UNITED STATES
DEPARTMENT OF THE INTERIOR
BUREAU OF LAND MANAGEMENTFORM APPROVED
OMB NO. 1004-0135
Expires: November 30, 2000**SUNDRY NOTICES AND REPORTS ON WELLS**
Do not use this form for proposals to drill or to re-enter an abandoned well. Use form 3160-3 (APD) for such proposals.**SUBMIT IN TRIPLICATE - Other instructions on reverse side.**

ConocoPhillips proposes to plug and abandon this well as per the attached procedure. Also attached are the current and proposed wellbore schematics.

PLUG AND ABANDONMENT PROCEDURE

Gage LS #3

Proposed P&A

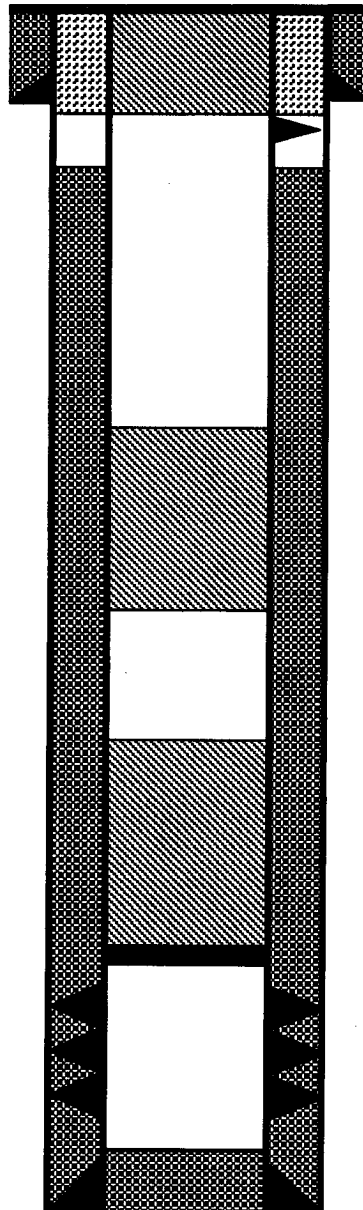
2. TOH and tally 1-1/4" tubing, total 2888'. Round-trip 4-1/2" casing scraper or wireline gauge ring to 2754'.
3. **Plug #1 (Pictured Cliffs perforations and Fruitland top, 2754' – ²⁸2448')**: RIH and set 4-1/2" cement retainer at 2754'. Pressure test tubing to 1000#. Sting out and load casing with water and circulate the well clean. Pressure test casing to 500#. If casing does not test, then spot or tag subsequent plugs as appropriate. Mix ²⁹29 sxs cement and spot a balanced plug inside casing above the retainer to isolate the Pictured Cliffs perforations and to cover the Fruitland top. PUH to 1626'.

4. **Plug #2 (Kirtland and Ojo Alamo top, 1626' – ⁰⁴1426')**: Mix ²¹15 sxs cement and spot balanced plug inside casing to cover the Kirtland and Ojo Alamo tops. TOH and LD tubing'.

5. **Plug #3 (8-5/8" Surface casing, 263' - Surface)**: Perforate 2 squeeze holes at 263'. Establish circulation out the bradenhead valve with water. Mix and pump approximately 85 sxs cement down the 4-1/2" casing to circulate good cement out bradenhead valve. Shut well in and WOC.

$$\begin{aligned} 263 / 11.167 (1.18) &= 22 \text{ sxs} \\ 50 / 4.3877 (1.18) &= 10 \text{ sxs} \\ 213 / 4.046 (1.18) &= 45 \text{ sxs} \\ \hline &77 \text{ sxs} \end{aligned}$$

$$(1626 - 1404) + 50 / 11.167 (1.18) = 21.5 \text{ sxs}$$

$$(2754 - 2428) + 50 / 11.167 (1.18) = 27.5 \text{ sxs}$$
